TECHNICAL MEMORANDUM

To: **Emily Anderson, Alaska Program Director, Wild Salmon Center**

From: **André Sobolewski, Clear Coast Consulting, Inc**

Subject: **Review of water treatment plants proposed in FEIS for Pebble Project**

Figure 1. Water Treatment Plant #2 - Operations Phase. Taken from USACoE FEIS Appendix N – Project Description

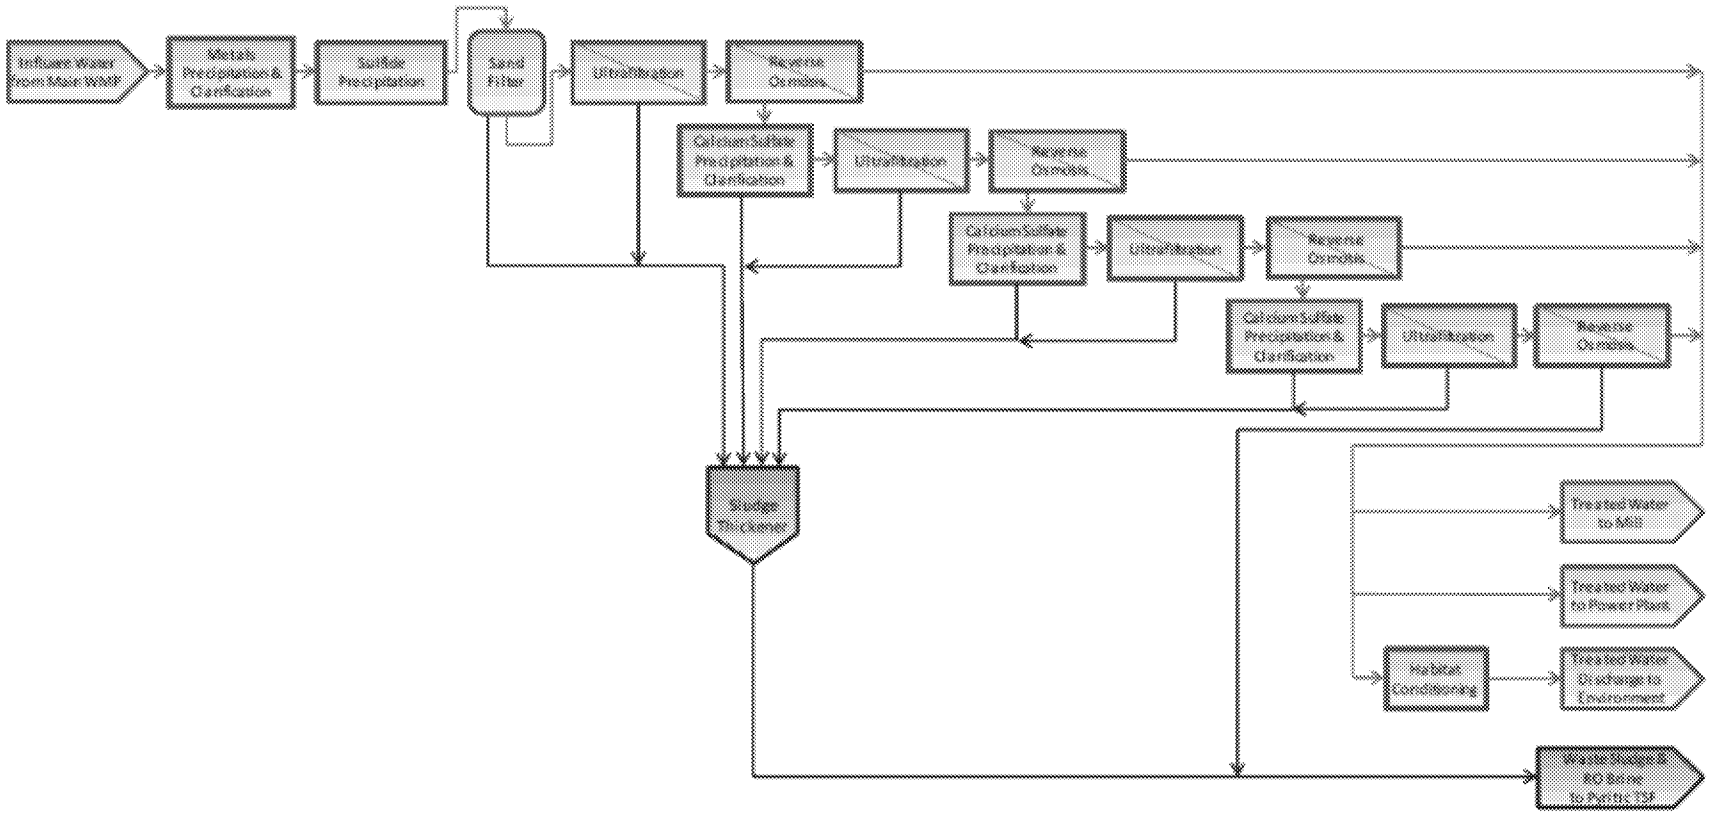
For this analysis, I used the proposed WTP #2 for mine operations (Figure 1), as it is among the most comprehensive WTP proposed for this project (WTP #3 also comprises an evaporator/crystallizer unit). This treatment system shares many components with WTP #1 and WTP #3 and any analysis of WTP #2 will readily apply to these other treatment plants.

The first step in the treatment process – permanganate oxidation and ferrihydrite precipitation – is effective in removing arsenic and manganese and is widely used. Depending on treatment conditions (pH, ORP), molybdenum will also be removed to acceptable levels, as evident by the treatment plant at the closed Brenda Mine (Aubé and Stroiazzo, 2000) and at Coldelco's El Teniente Mine (Aubé and Vergara, 2010).

Permanganate oxidation, followed by ferrihydrite precipitation is reported to remove selenium (RFI 021e Addendum, 2019), but this is incorrect. Ferrihydrite precipitate the *partially-reduced* selenite (SeO_3^{2-}), not the *full oxidized* selenate (SeO_4^{2-}). Thus, an initial reductive step is required to reduce the unreactive selenate to selenite, like the addition of zinc dust (Alberta Environment, 2005), and to remove it via iron co-precipitation. The latter reaction is effective in decreasing high inflow concentrations of selenium, but it can only decrease its levels to ~0.020 mg/L. An additional step is necessary to decrease its concentration < 0.005 mg/L.

Selenium is proposed to be removed as a selenide via precipitation with sulfide. This reaction is technically possible and has been demonstrated in the laboratory, but it requires conditions that are not met in a mining environment (low redox potential, high sulfide concentrations, etc). To my knowledge, this process has never been used in a commercial application, and certainly never at a large-scale mining operation. Several specialists who know or investigated this process[1] have confirmed that it is impractical for selenium removal from mine water.

In the absence of chemical precipitation, selenium will be removed in the WTP by membrane filtration, either via nanofiltration or reverse osmosis. Given that selenium-containing brine generated by membrane filtration will be discharged into the Pyritic TSF, there is a concern that its concentration will build up in mine water because WTP #2 → Brine → Pyritic TSF → Main WMP → WTP #2 is a closed-loop circuit. This concern was acknowledged by Pebble and was analyzed through a water balance and water chemistry model (Knight Piésold, 2019). I reviewed this model.
